Vehicle: All Technical Service Bulletins
Aftermarket Radio May Set DTC'S 72 and 74 In CCM
Number: 93-68-9A

Subject:
AFTERMARKET RADIO MAY SET DTC'S 72 AND 74 IN CCM

Model and Year:
1990-93 CORVETTE

INTERIOR LIGHTS DIMMING LED AND LCD WITH C68 ELECTRONIC AIR CONDITIONING

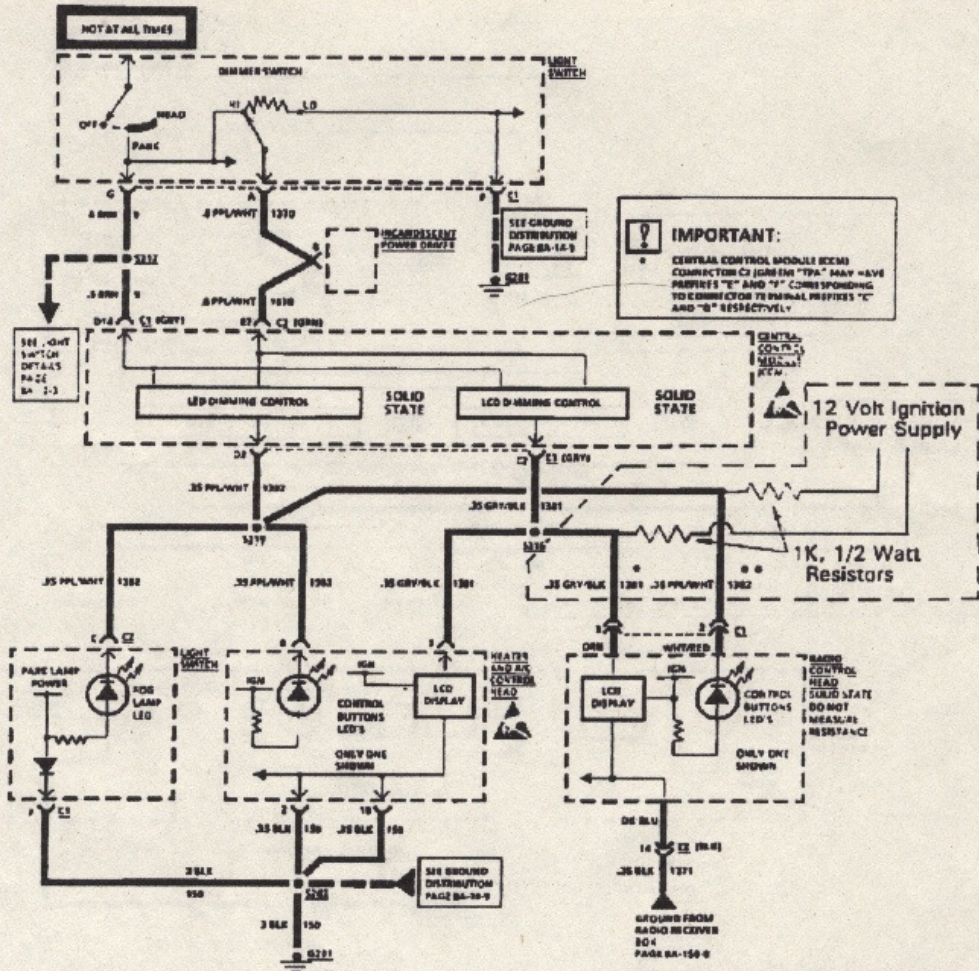
With an aftermarket radio installed, DTC's 72 and 74 are likely to be set because the LCD and LED dimming lines to the radio have gone to an open circuit, because these inputs do not exist in an aftermarket radio.

3. Add 1K ohm, 1/2 watt resistors as shown in the illustration. The resistors are available from a local electronics supply store, such as *Radio Shack. The resistors should be connected to a 12 volt ignition-switched circuit. For 1991 to 1993, there is an auxiliary power pickup in the console. For 1990, ignition circuit number 300 should be used. See Section 8A for wiring details.
4. Reinstall the radio, then reconnect negative battery cable. Clear the CCM DTC's as shown in Section 8D, and verify proper operation.
